County of Roanoke

IFB #2018-95

Explore Park Lift Station & Gravity Sewer Line

ADDENDUM NO. 3

**EXPLORE PARK
GRAVITY S.S. EXTENSION**

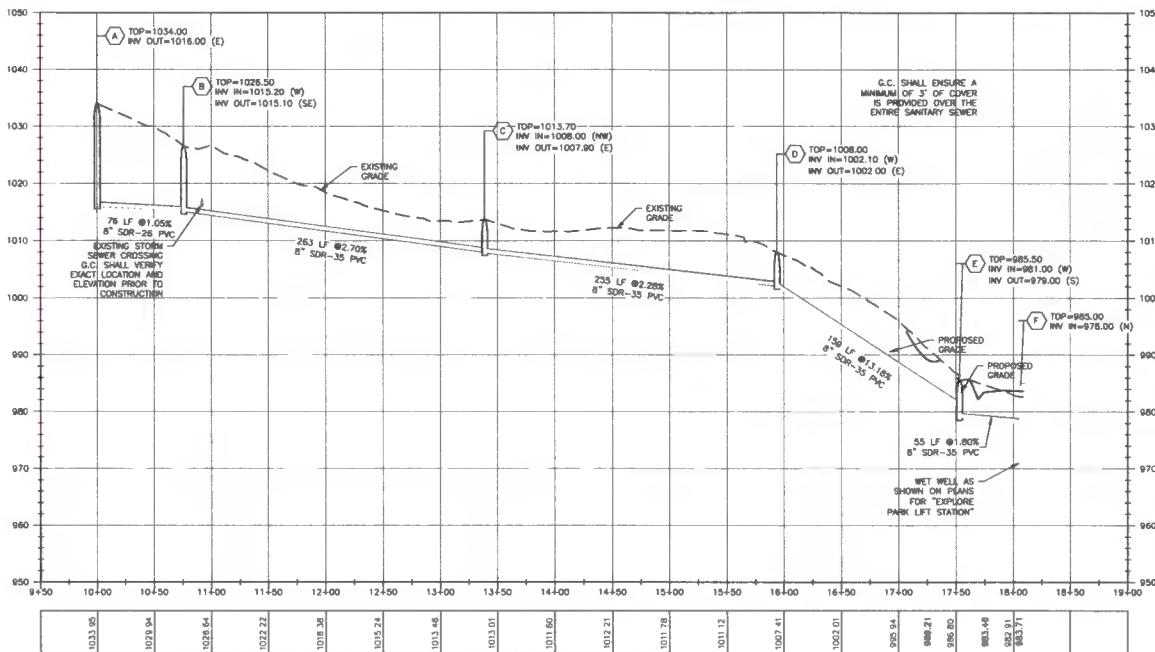
- 4) Can a pavement patch detail be provided?

- 5) Can a stone patch detail be provided?

16) Can you provide a paved walkway detail?

Answer: Now shown on Gravity S.S. Extension sheet C3.

Answer: Now shown on Gravity S.S. Extension sheet C3.

Answer: Now shown on Gravity S.S. Extension sheet C3.

PAVEMENT REPLACEMENT SECTION
M.T.S.

PAVED WALKWAY SECTION

C3

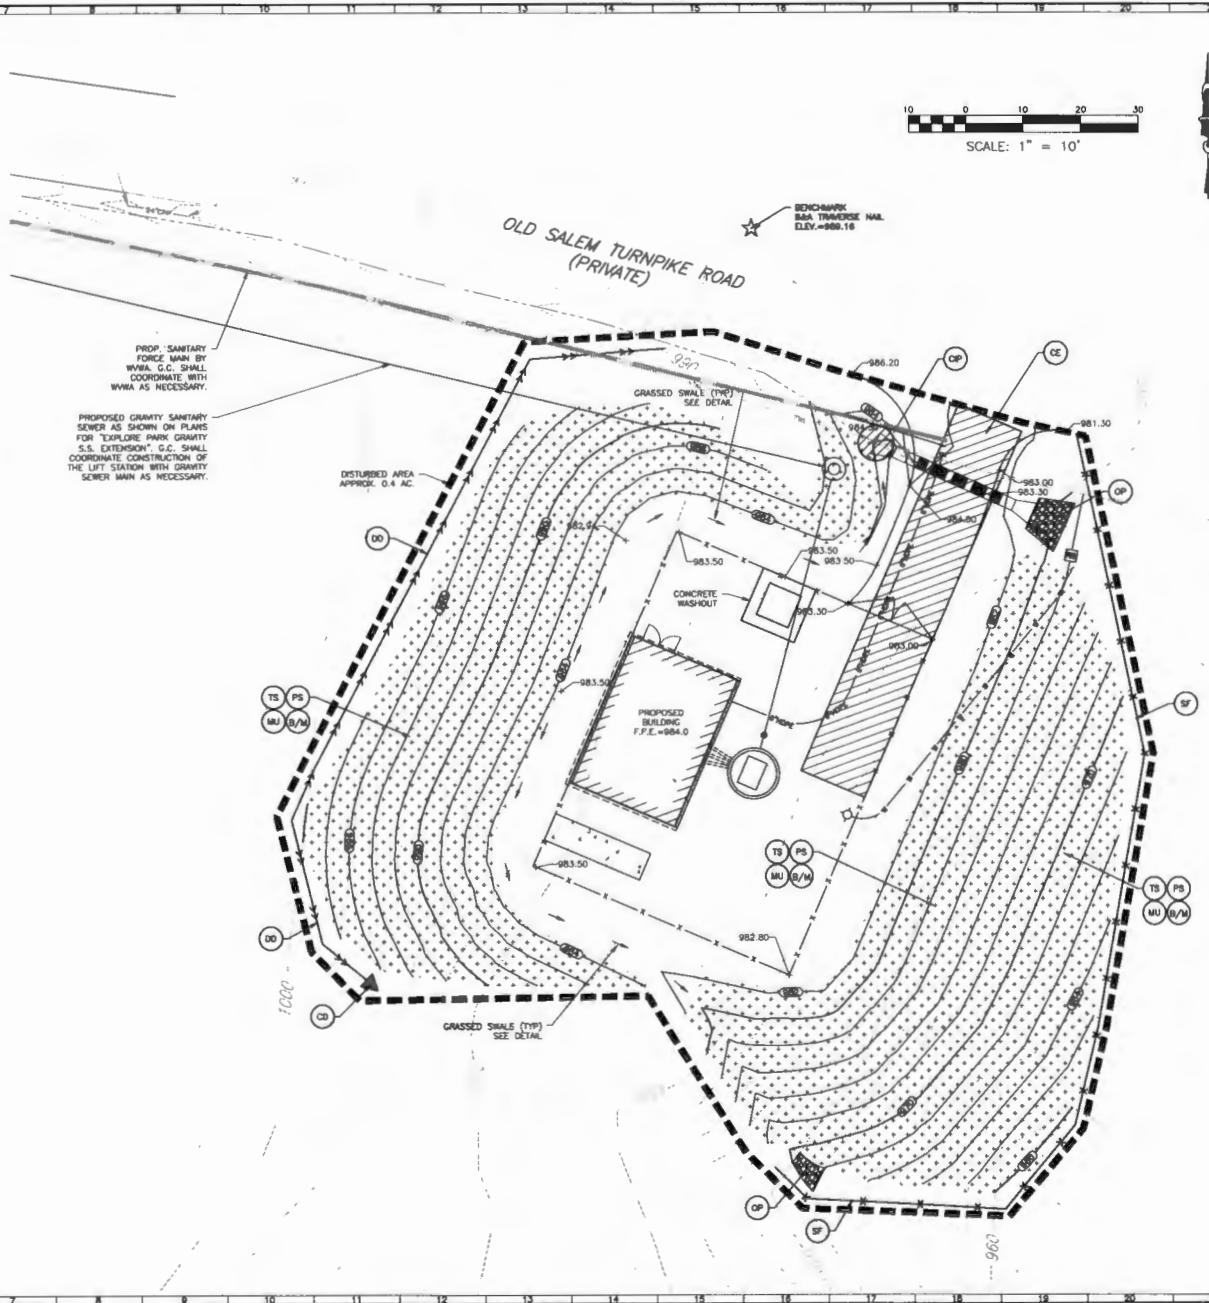
10) The plans refer to "blanket matting" on steep slopes. Can these areas be identified? Can type of matting be identified?

Answer: Now shown on Lift Station sheet C3. Matting to be VDOT Std. EC-2.

DITCH SHALL RECEIVE
VOOT STD. EC-2 LINING
SEE DETAIL ON SHEET C5
